ONE 90 (PREVIOUSLY WATERS TECHNOLOGY PARK )  
PA 18-013 MODIFICATION SUBMITTAL :  
ISSUE DATE: 10-13-20

PA MODIFICATION - INTENT AND DESCRIPTION:  
To review and approve architectural building related design modifications made during plan check for code compliance and constructibility.

PA MODIFICATION COBALT- BLOCKS REVISIONS SUMMARY

PA MODIFICATION - INDIGO ROWS REVISIONS SUMMARY

GROUND LEVEL PLAN TH10

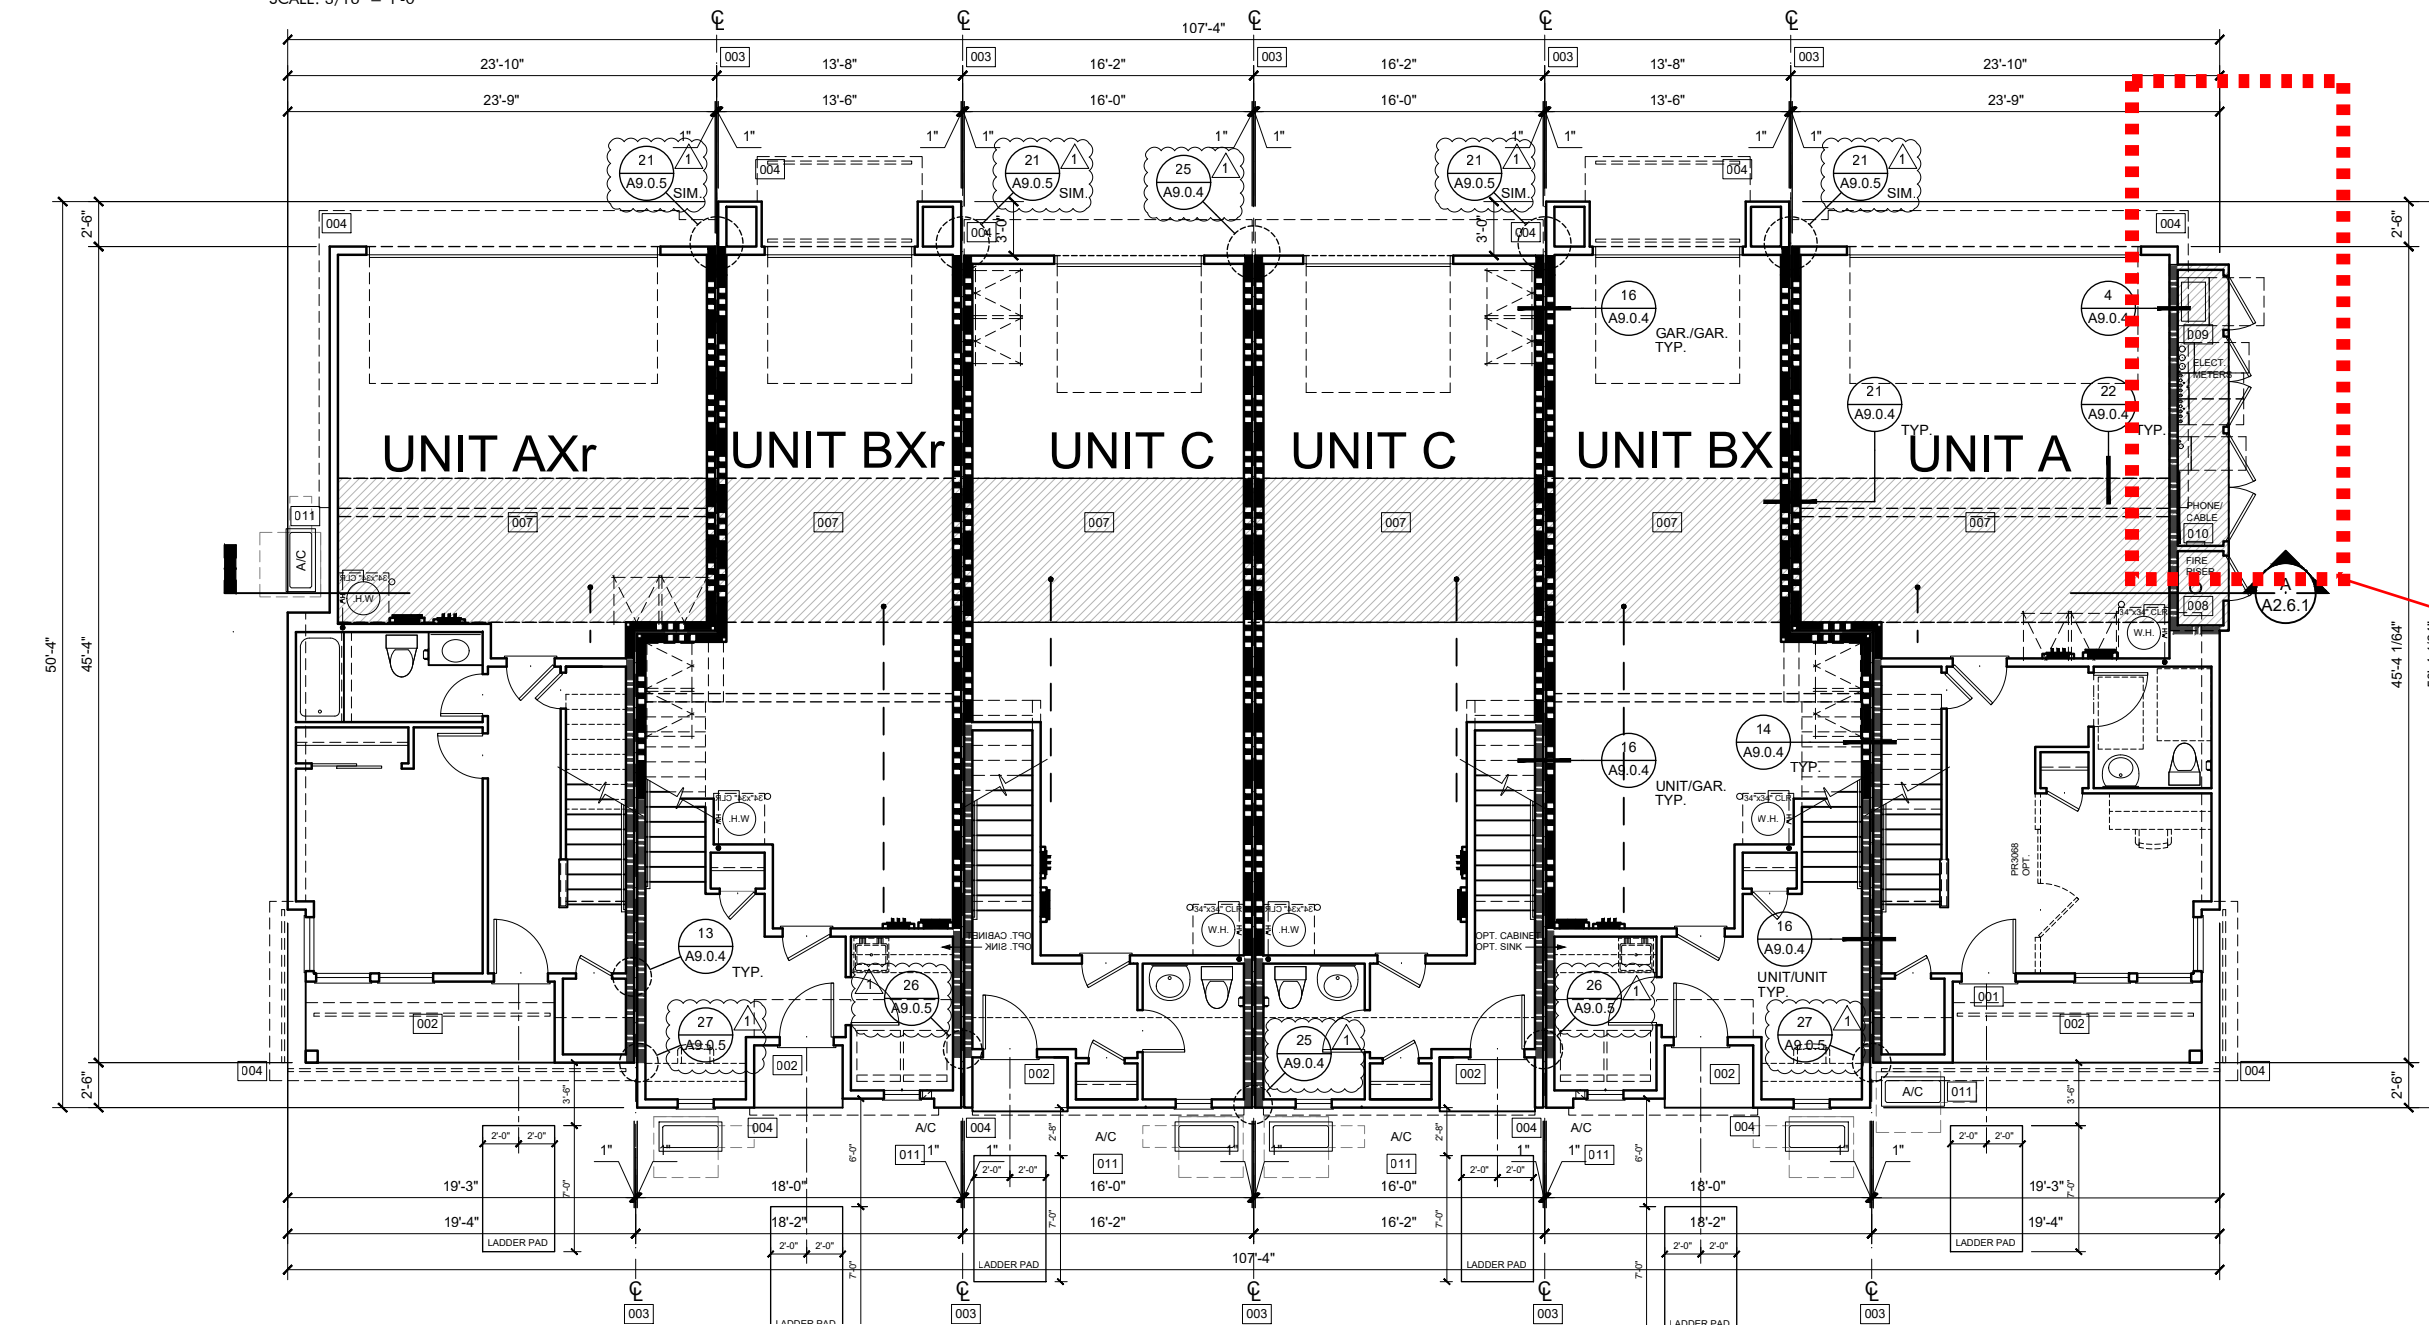
1. Added fire and electrical utility closets  
Townhome 10 is currently renamed as Building A on the revised siteplan.

Please note that PA 18-013 plans did not include dimension and the second floor dimensions were measured to interior of the walls and did not include any dimensions to exterior pop out walls.

LEFT ELEVATION

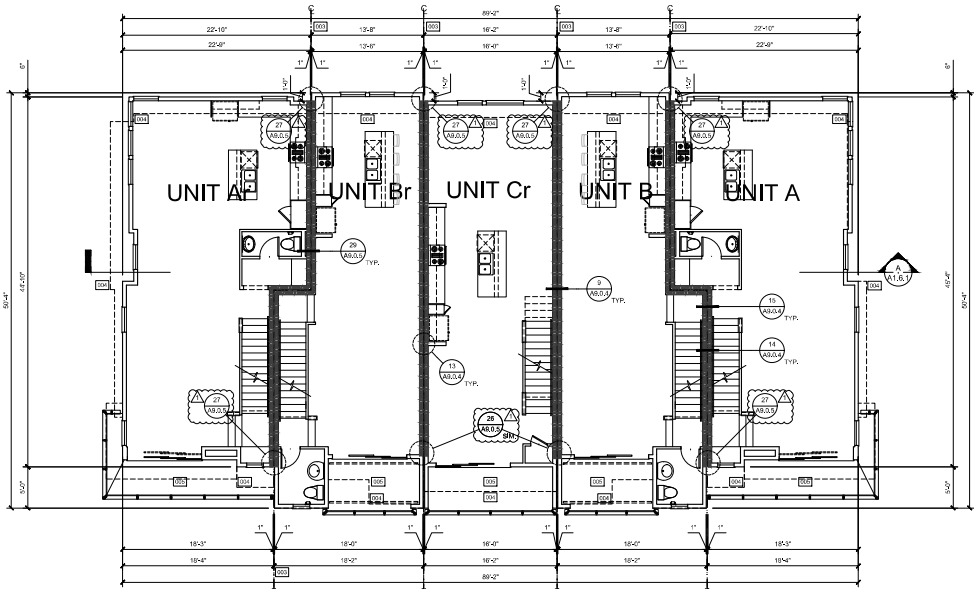
THIS DIMENSION IS MEASURED TO T/SLAB AND NOT TO GRADE. WE CANNOT HAVE 8'-1" TO GRADE AS THAT WILL RESULT IN LESS THAN 7'-10" INTERIOR DIMENSION AND IT IS NOT CODE COMPLIANT AND ALSO DOES NOT MATCH THE SECTION SHOWN ON SHT A 2.2

- List of Minor Revisions:
- 1. Minor window configuration to meet egress and interior livability.
  - 2. Removed canopy/overhangs at rear elevation to avoid conflict with ladder pads.
  - 3. Added utility closets.
  - 4. Window and sliding door color changed to white or tan.

- List of Revisions:
1. Minor window configuration to meet egress and interior livability.
  2. Removed canopy/overhangs at rear elevation to avoid conflict with ladder pads.
  3. Added utility closets.
  4. Window and sliding door color changed to white or tan.
